PD Modification Application: PRS 23-0968

BOCC Land Use Meeting Date: 12/12/23

Request Minor Modification to PD 83-0266

Existing Approval(s):	Proposed Modification(s):
The approved site plan requires: (1) 2 entrances/egress to Eichenfeld Drive.	The requested change is to: (1) reduce access onto Eichenfeld Dr. to 1 entrance/exit.
(2) setbacks shown on the SP are 15 ft. from the property line located in two structures.	(2) allow a setback of 5 feet along the eastern boundary to construct a one-story medical facility within one building.

2.5 Proposed Site Plan

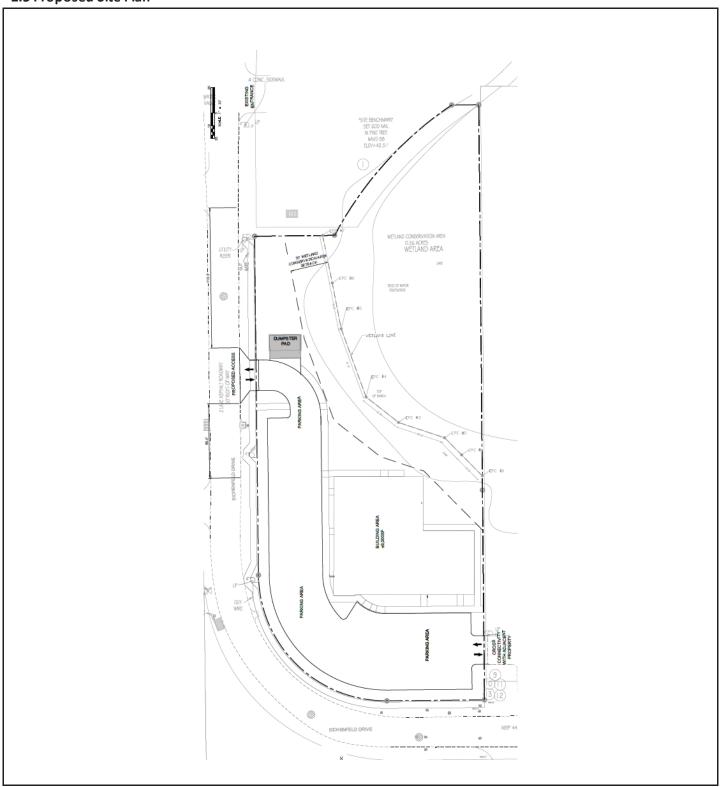
The applicant is proposing to modify the location of the medical office closer to the adjacent property. The current site plan was approved with up to 10,000 sf of medical space and 7,044 sf of office space, while the application proposes a maximum of 9,000 sf of medical space. However, the overall medical building has been revised to be a one-story medical facility instead of the four-story, 50-foot medical facility approved via PRS 12-0022. The overall building's reduction in height from a maximum height of 50 feet to a maximum height of 30 feet requires the footprint to be shifted. The applicant is proposing a side yard setback reduction from 15ft to 5ft. The applicant also proposes to reduce the amount of driveway entrances to eliminate one driveway, while keeping an east cross-connection to the adjacent parcel located within the PD. The applicant also proposes to maintain one (1) driveway connection to Eichenfeld Drive at the northwest side of the property.

Staff finds the request Approvable, subject to the following conditions listed below, and based on the general site plan submitted November 22, 2023.

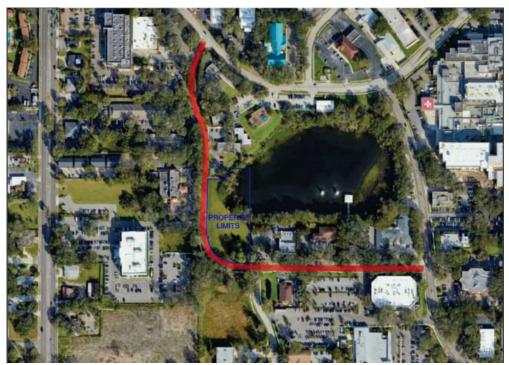
Eichenfeld Drive was found to be substandard in regard to LDC 6.04.03 L which states the following:

Acknowledging that neither full, nor partial conformance with the TS-3, Urban Local Roads (2 Lane Undivided) Typical Section under the existing conditions of Eichenfeld Drive, George F. Young is requesting an <u>Administrative Variance</u> for relief from the requirements to improve Eichenfeld Drive to meet roadway standards set forth in TTM detail TS-3. Please refer to Appendix A, TTM detail for reference.

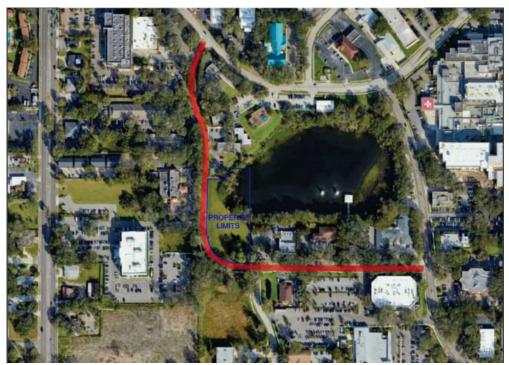
Eichenfeld Drive was found to be substandard in regard to LDC 6.04.03 L which states the following:

Acknowledging that neither full, nor partial conformance with the TS-3, Urban Local Roads (2 Lane Undivided) Typical Section under the existing conditions of Eichenfeld Drive, George F. Young is requesting an <u>Administrative Variance</u> for relief from the requirements to improve Eichenfeld Drive to meet roadway standards set forth in TTM detail TS-3. Please refer to Appendix A, TTM detail for reference.
